ADDENDUM NO. 1

LOWER VALLEY WATER DISTRICT

PANORAMA VILLAGE LIFT STATION 19 (PACKAGE 4)

BID No. 24-0105-01

JOB NO. 21-117
SHEET NUMBER C1.2

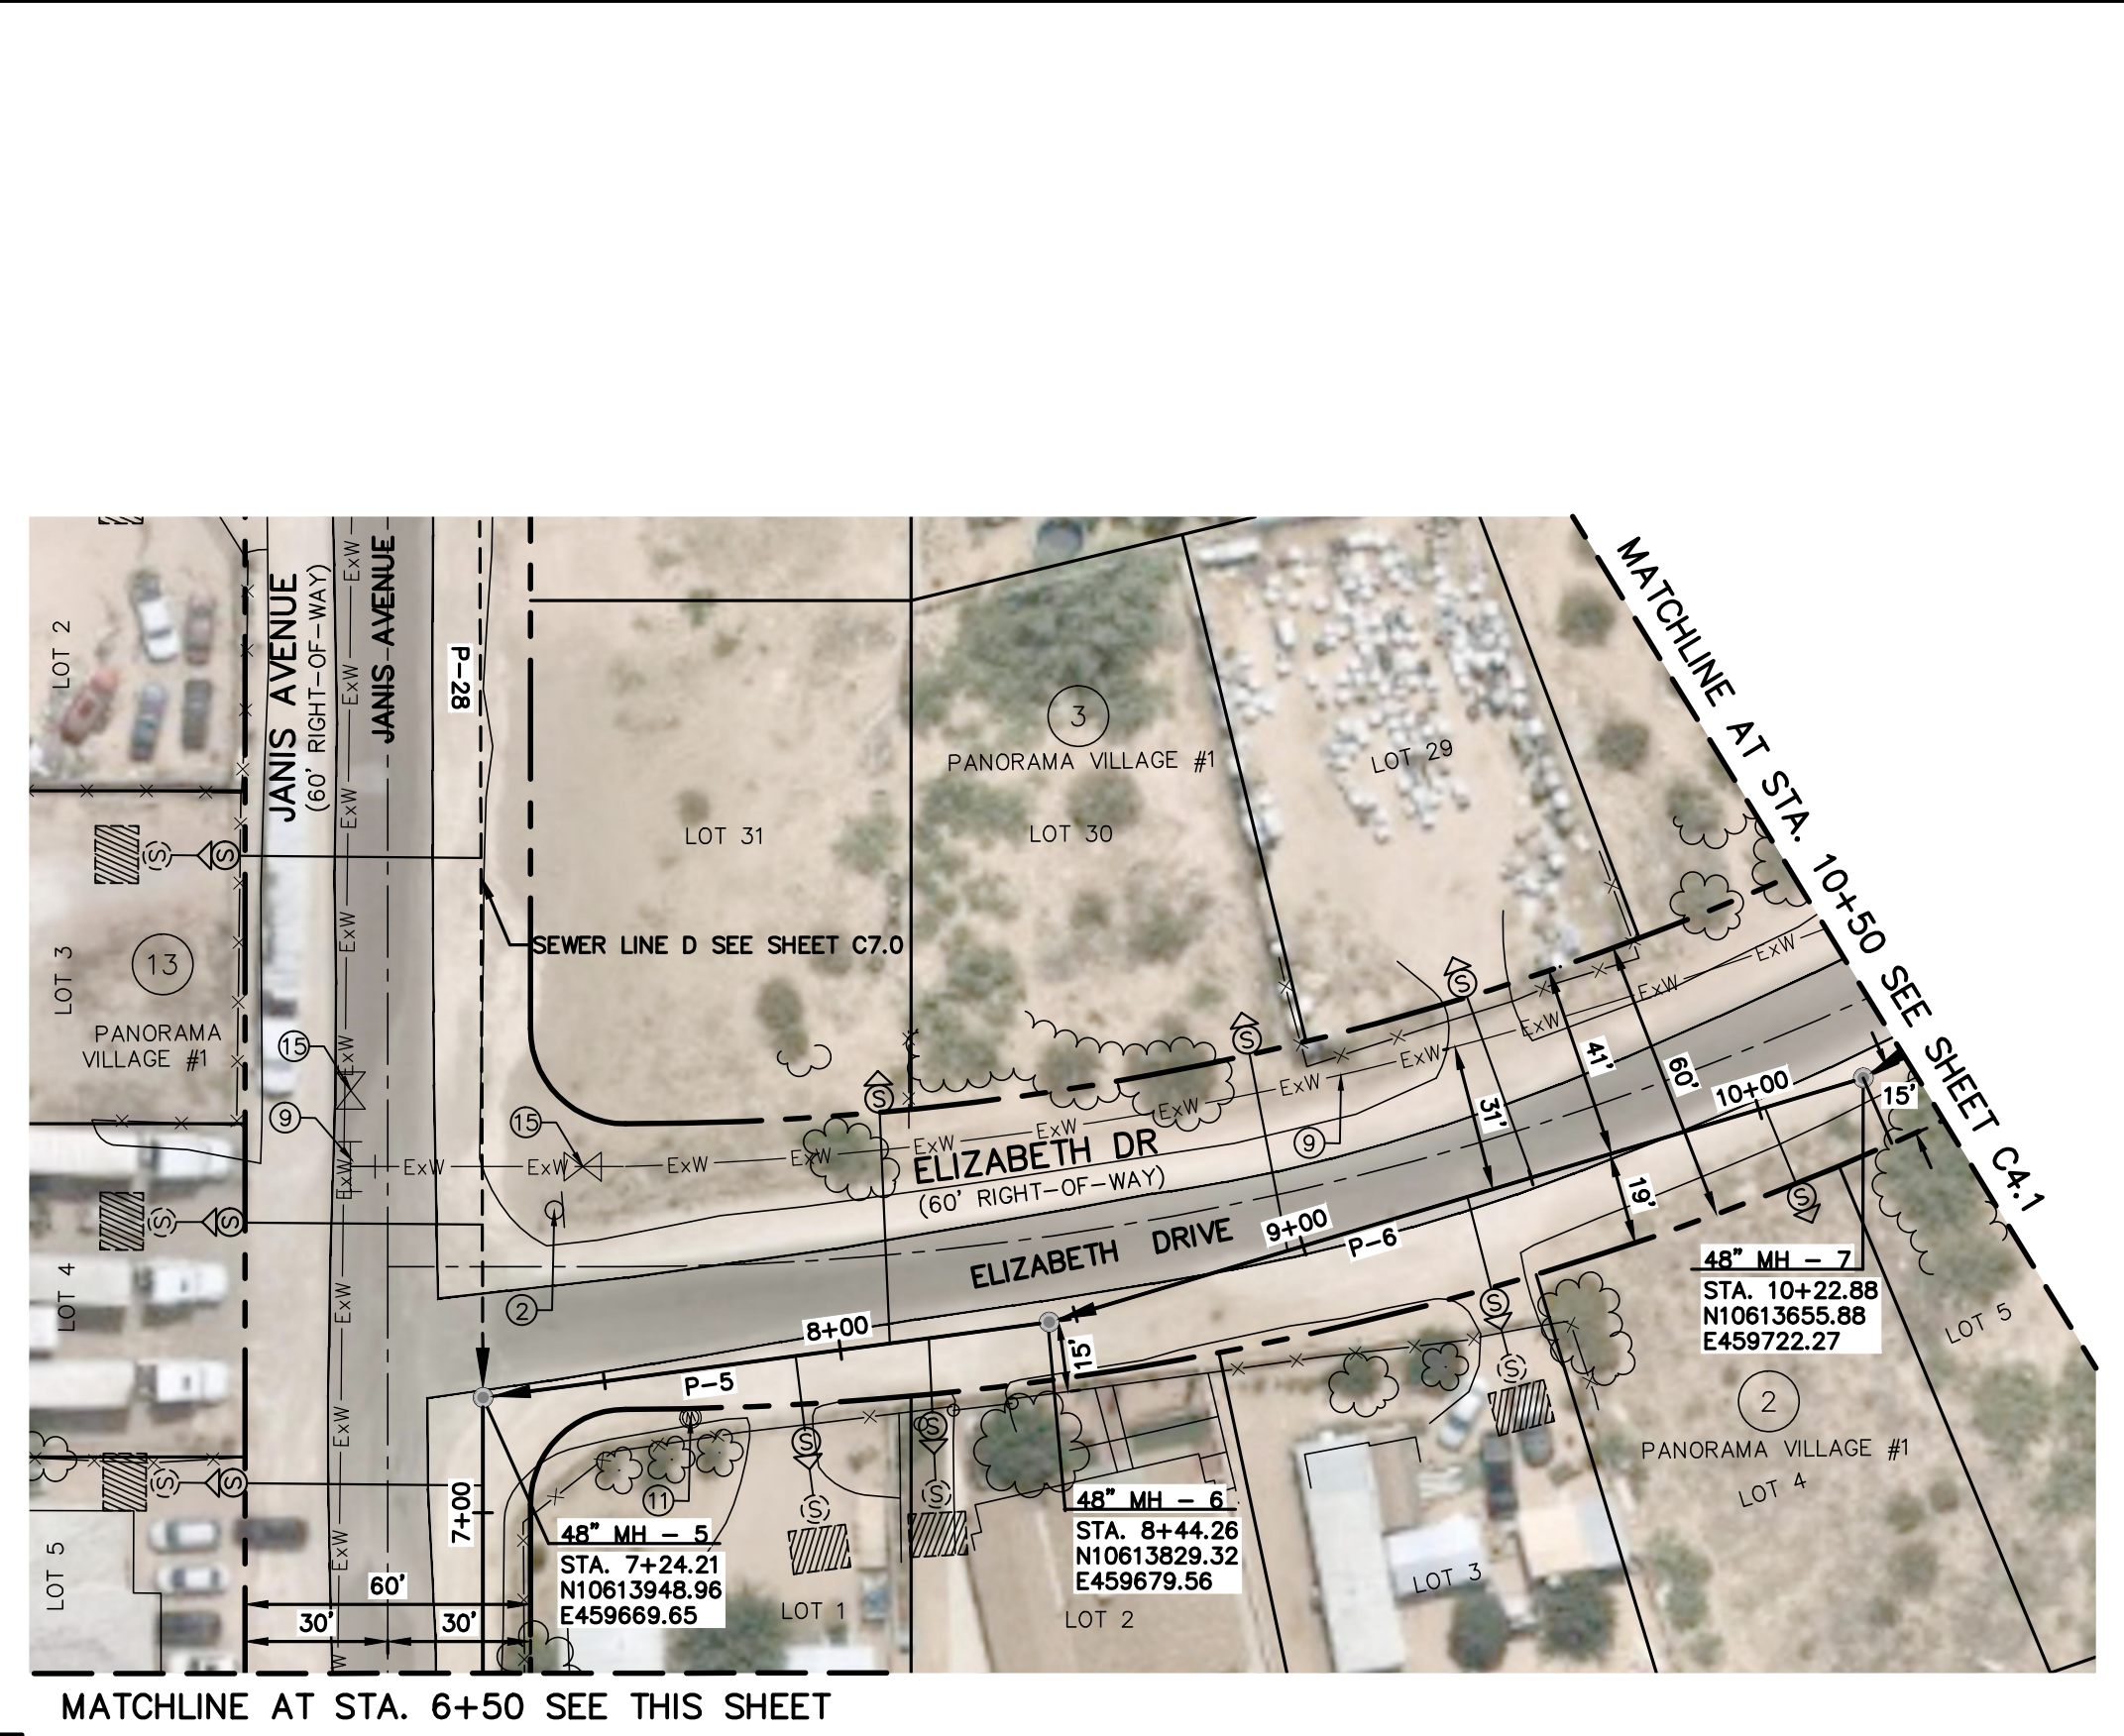
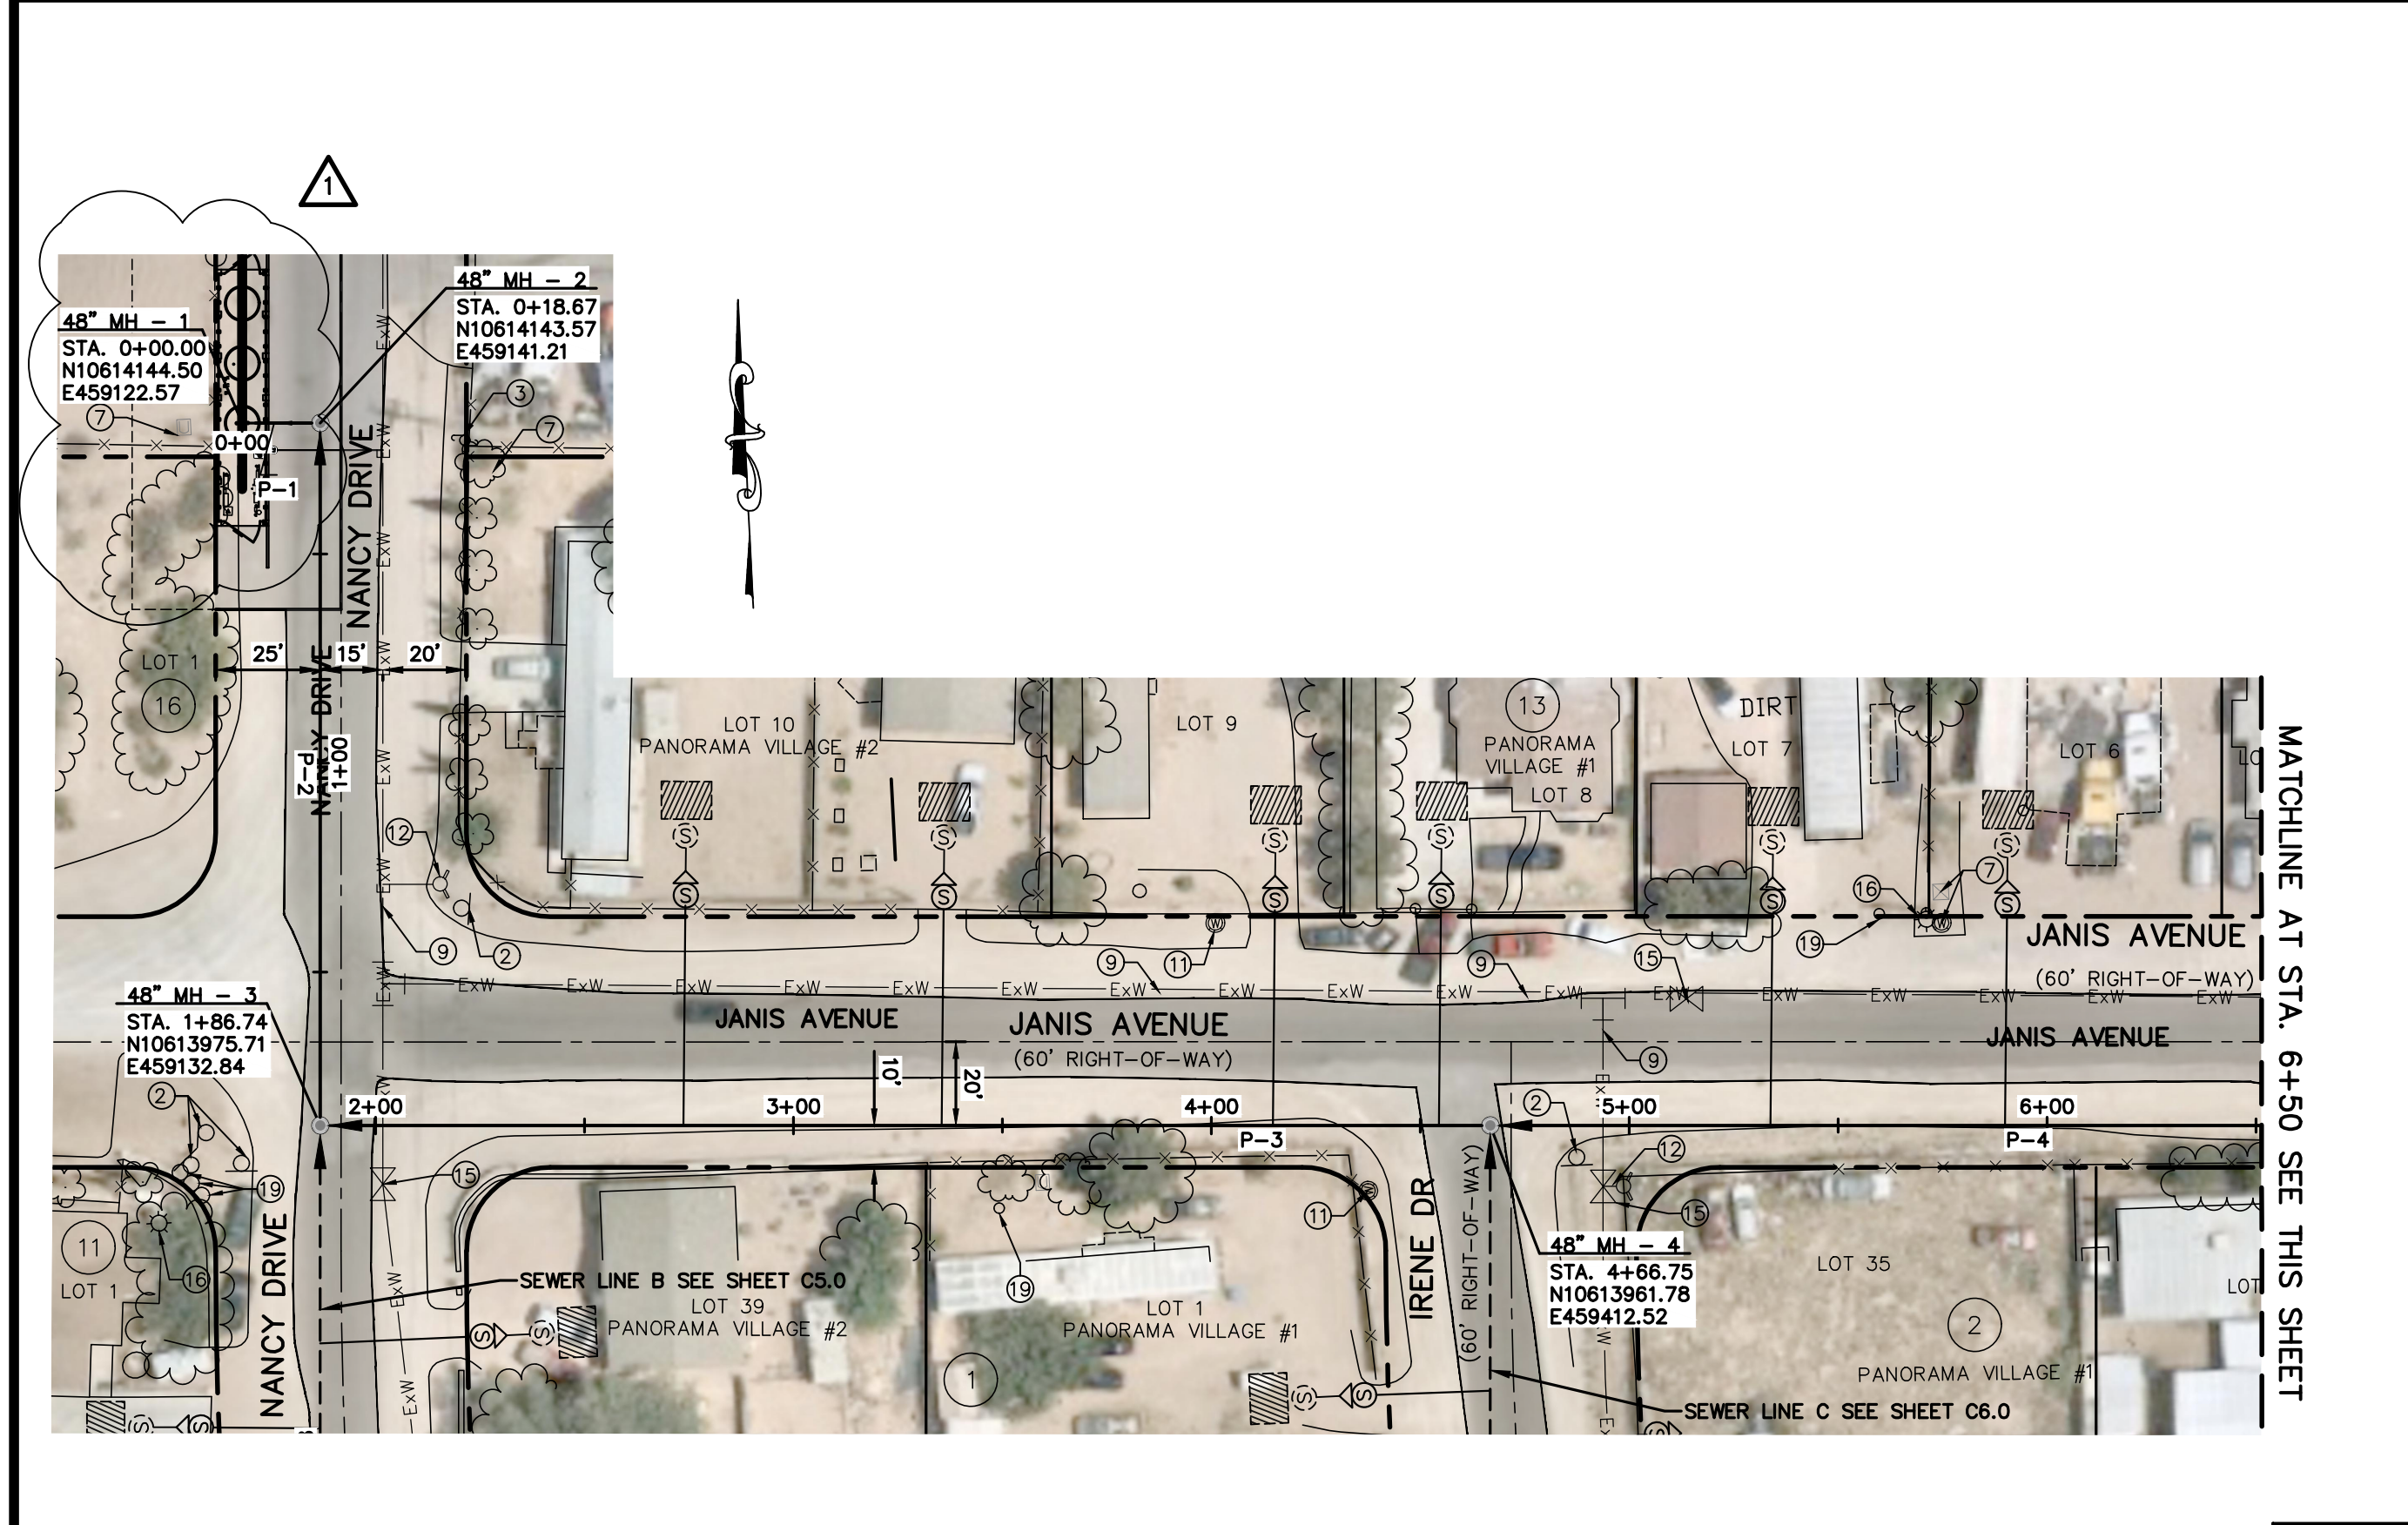
1. Design Sheet “C1.2” was updated to reflect the corrected easement limits. Design Sheet “C1.2” sheet to be **DELETED** and **REPLACED** in its entirety with **ATTACHMENT B**.
2. Design Sheets “C3.0”, “C4.0”, “C8.0”, “C12.1”, “E3.0”, AND “E4.0” were changed to show the new area of the lift station concrete slab. Design Sheet “C3.0”, “C4.0”, “C8.0”, “C12.1”, “E3.0”, AND “E4.0” sheets are to be **DELETED** and **REPLACED** in their entirety with **ATTACHMENT B**.
3. Design Sheet “C8.3” was updated to correct the aerial background and update the stationing numbers. Design Sheet “C8.3” sheet to be **DELETED** and **REPLACED** in its entirety with **ATTACHMENT C**.

REV.	DATE	BY	DESCRIPTION
1	12/22/23	EC	REVISED EASEMENT LOCATION

JOB NO. 21-117
SHEET NUMBER C4.0

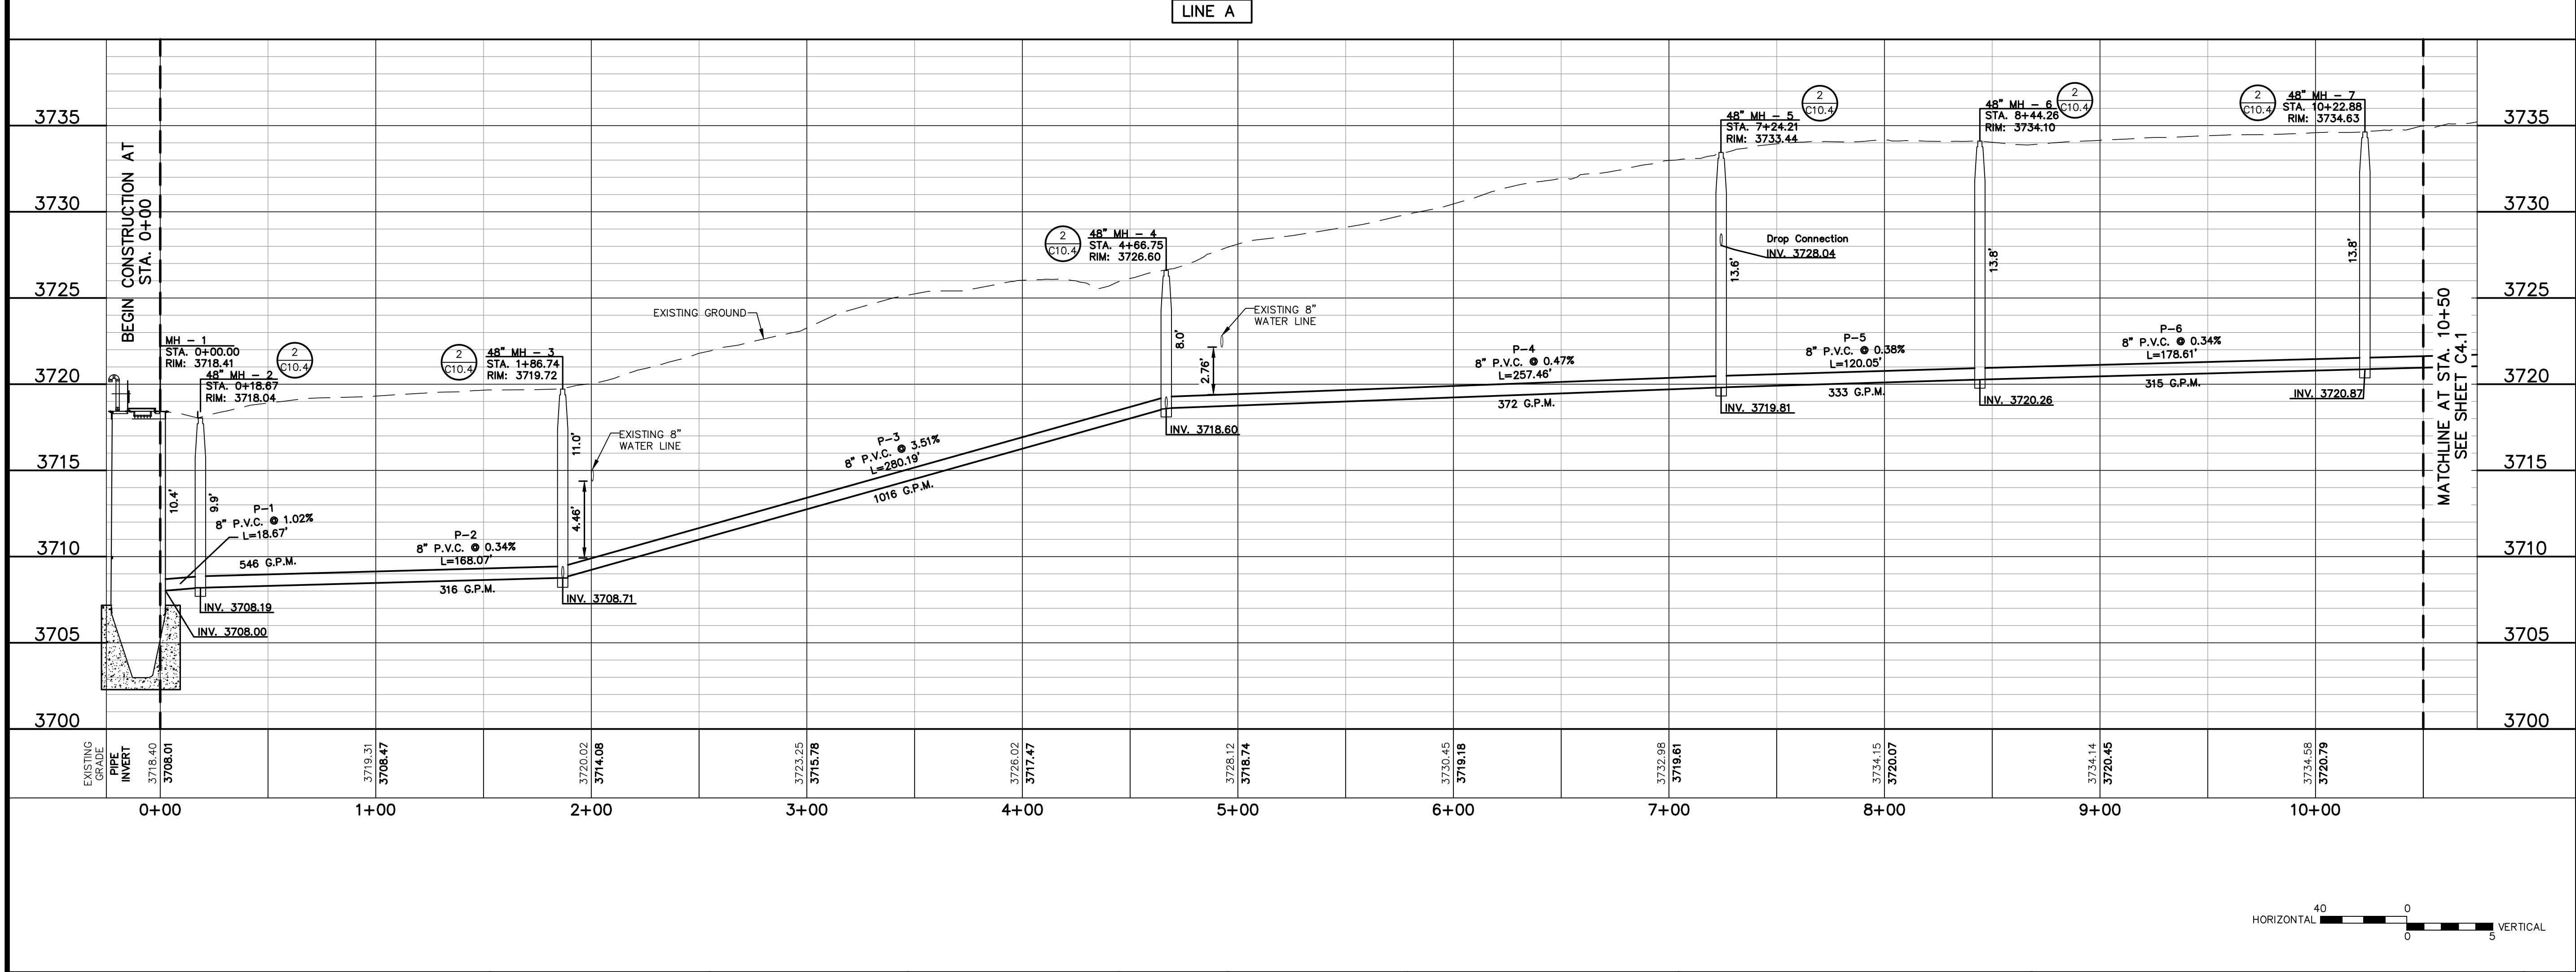
REV.	DATE	BY	DESCRIPTION
1	12/22/23	EC	REVISED CONCRETE SLAB
